TECHNICAL SPECIFICATIONS
FOR THE
UNIVERSITY OF MASSACHUSETTS LOWELL
RESEARCH REACTOR

FACILITY OPERATING LICENSE NO. R-125

Figure 6-1

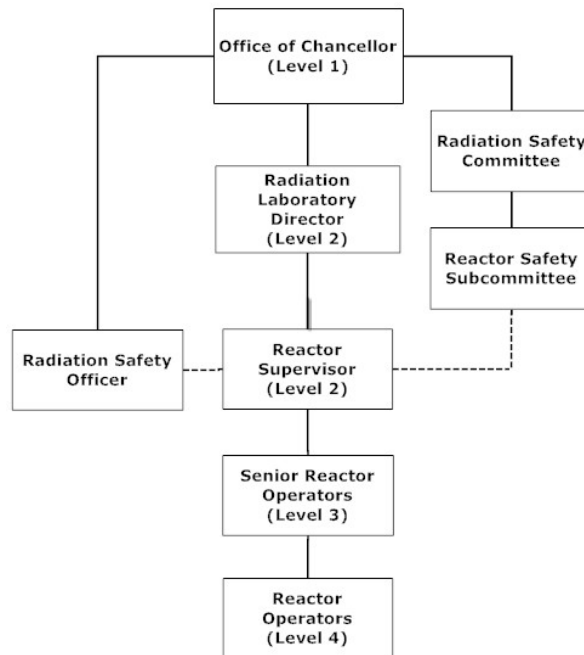
Comment [L84]: Chart revised per RAI 14.6.3 and mtg on 1/9/19.
